# REMARKS

Appl. No. 10/585,704 Amdt. dated 12/14/2011 Reply to Office action of 6/15/2011

# A. Example: Morales Compression Chamber

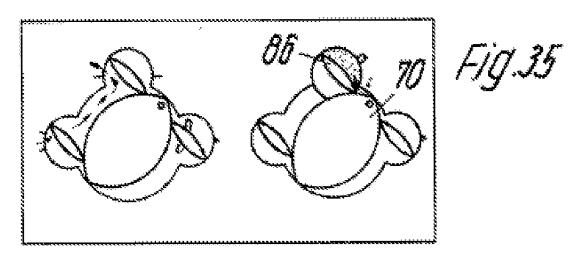
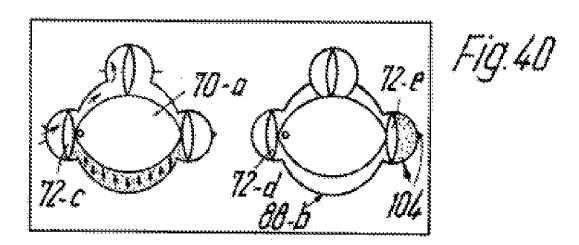
The unusual operation of the Morales engine can be understood, for example, with respect to the expansion of the working medium after combustion. Specifically, as shown in Morales Figs. 35-40 and in the related text (Morales page 16, line 3 to page 17, line 14) the expansion of the working medium begins in one chamber and against rotor 70 (see Fig. 35, and the text on page 16: "the expansion acting on the piston rotor 70 begins" –page 16, line 22). In Fig. 35, the working medium is beginning to expand against piston 70, and the expansion chamber is formed by piston 70, "valve" 86, and the housing:

However, the working medium does not complete its over expansion in that chamber. Rather, during the expansion, the working medium later passes through opening 100 (see Fig. 37), and then the "expansion continues to act on the rotor piston 70a" (page 17, lines 7-8). This is illustrated, for example, in Morales Fig. 40. In Fig. 40, the expansion continues against piston 70a, and the expansion chamber is formed by piston 70a, "valve" 72c, and the outer housing. Piston 70 no longer forms a part of the expansion chamber.

Therefore, the Morales compression, combustion and expansion volumes are not formed by a common rotor. Thus, it would be incorrect to conclude that the Morales engine teaches a "housing and piston successively define volumes in differing amounts within the housing for phases of compression, combustion, and expansion" as required by claim 37.

#### B. Example: Morales Combustion Chamber

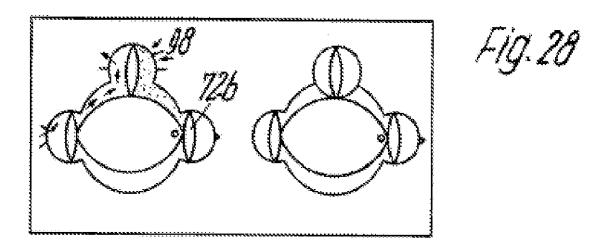
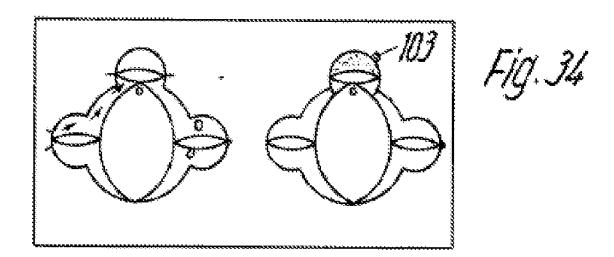
A similar observation may be made with respect to Morales's combustion chamber. Prior to combustion, Morales compresses the working medium in a compression chamber that is formed by piston 70a, and "valve rotors" 72b, along with the outer housing (see, for example, Figs. 28).

Next, the working medium is transferred to a combustion chamber. However, the combustion chamber is formed only by the outer housing and valve-rotor 86 - as shown in Fig. 34 – and not by rotor 70 or 70a. Applicant respectfully notes that valve-rotor 86 is not expressly identified in Fig. 34, but is identified in other figures, such as Fig. 25 and Fig. 35, and is therefore identifiable in Fig 34:

Therefore, again, the Morales compression, combustion and expansion volumes are not formed by a common piston.
